# **Ivilo Heights Subdivision Final Drainage Report**

**Colorado Springs, El Paso County, Colorado**

**April 2024**

**PCD No. SF245**

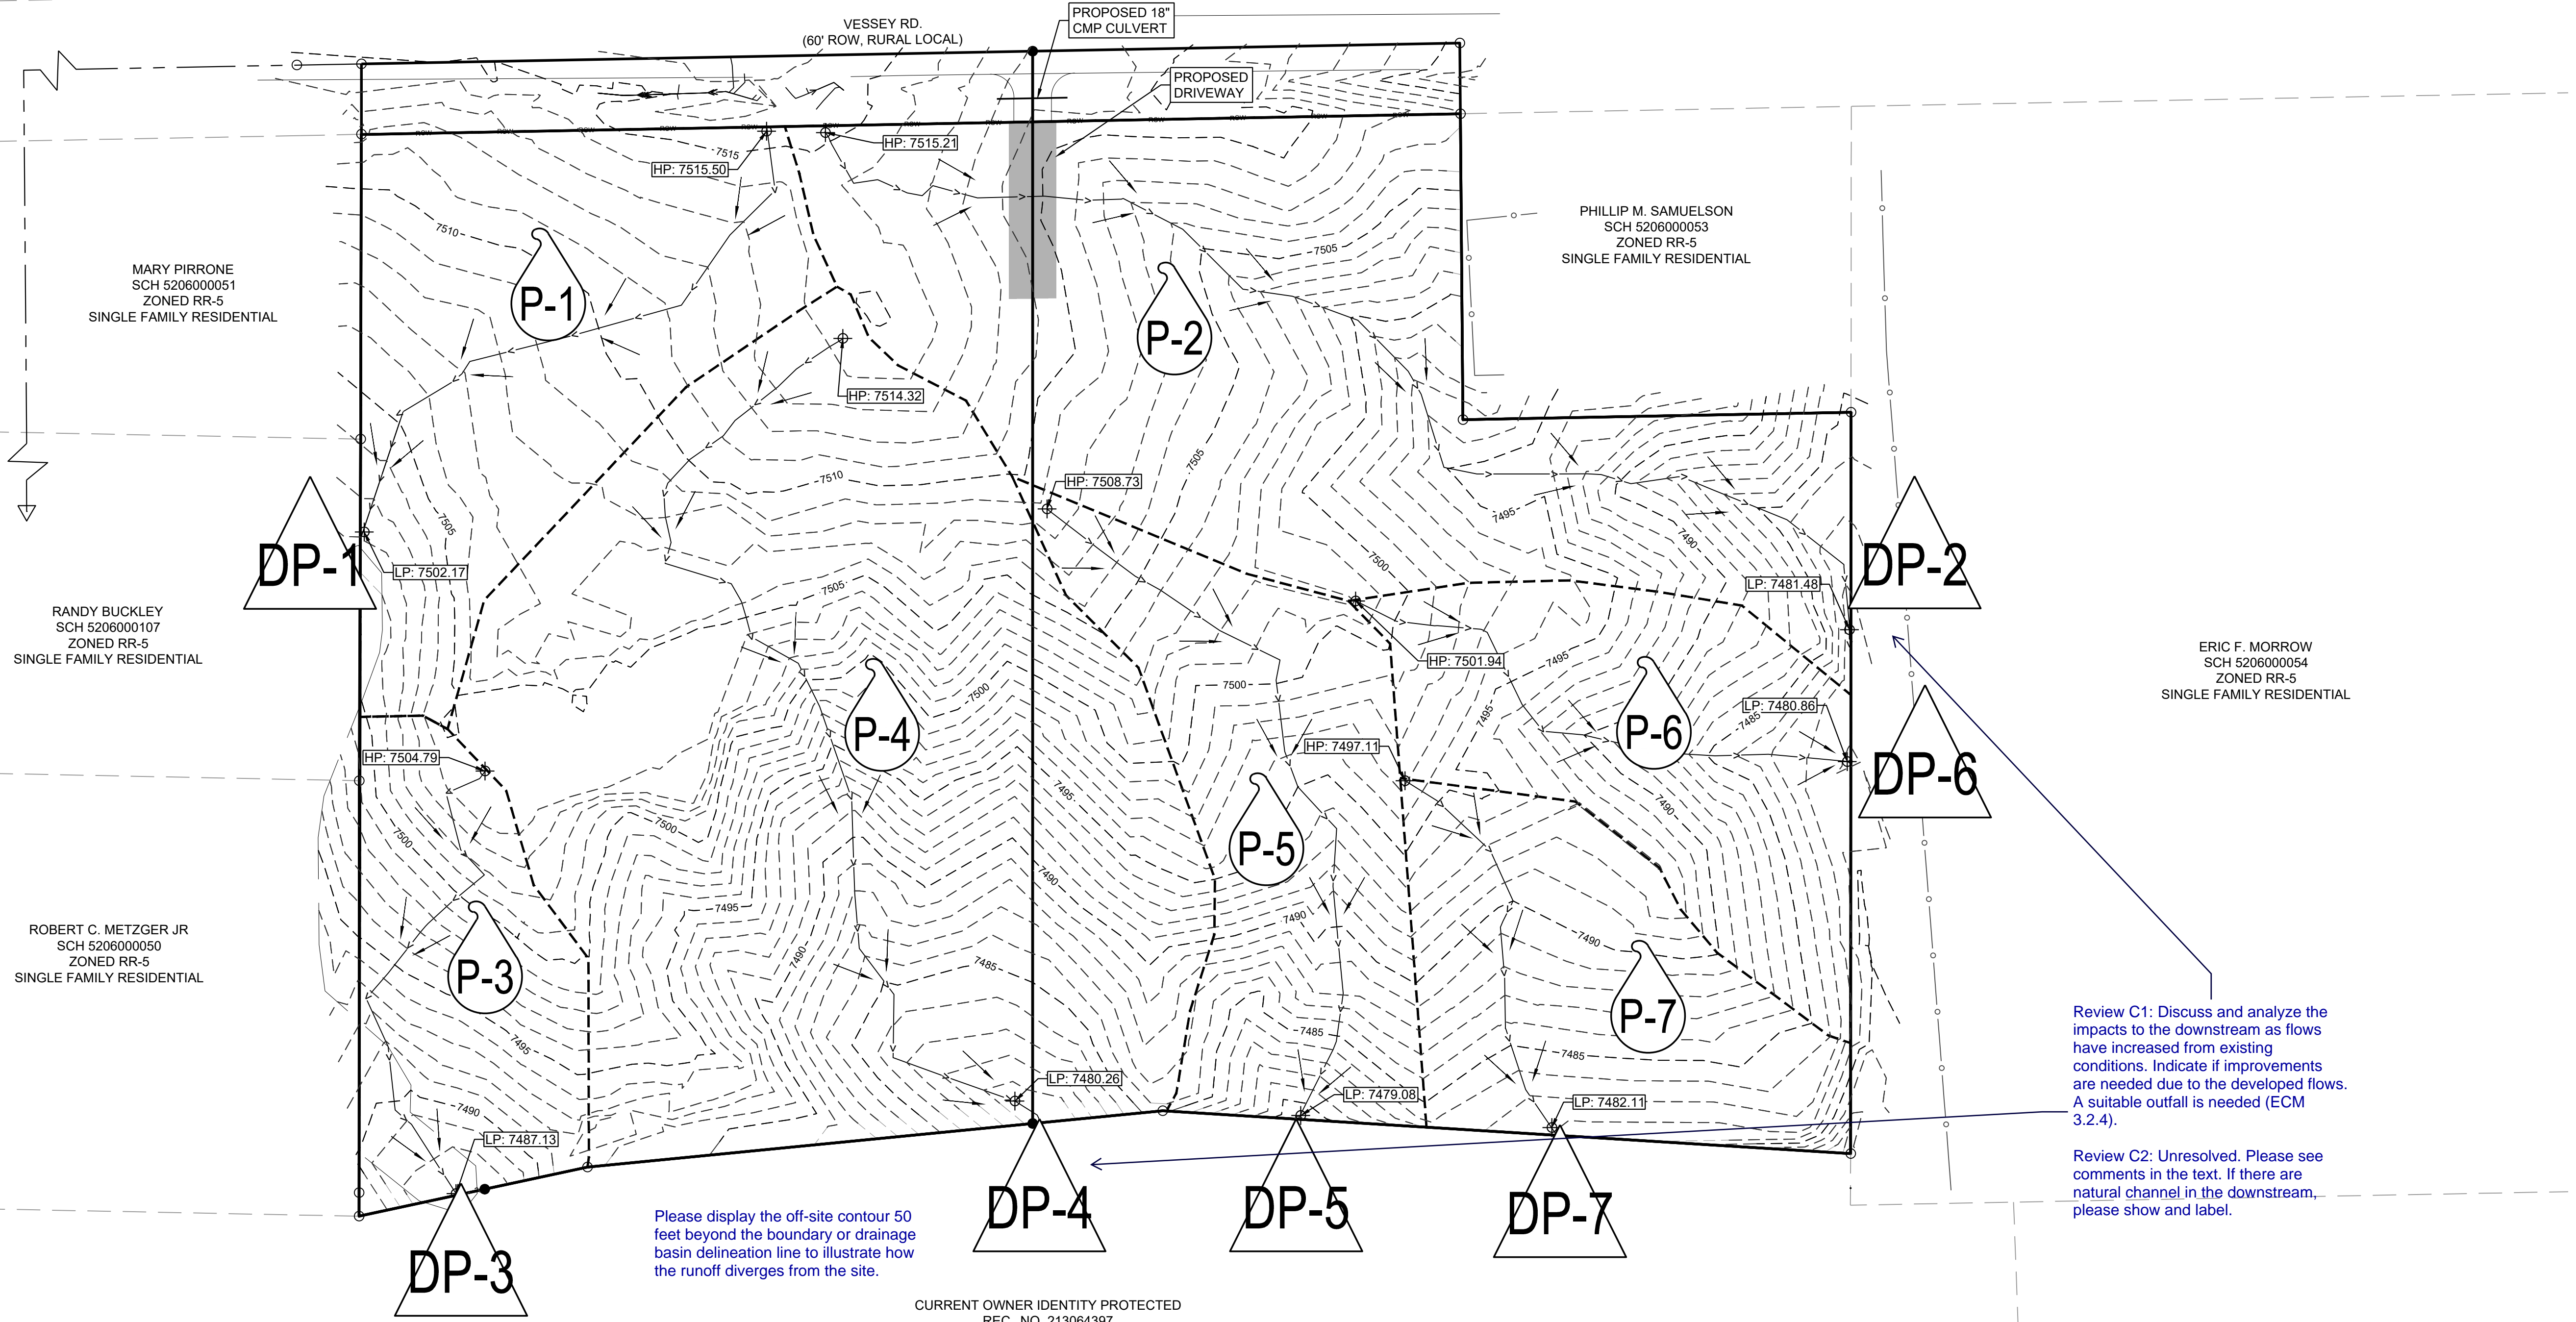
Review C2: Unresolved. Please see comments in the text. If there are natural channel in the downstream, please show and label.
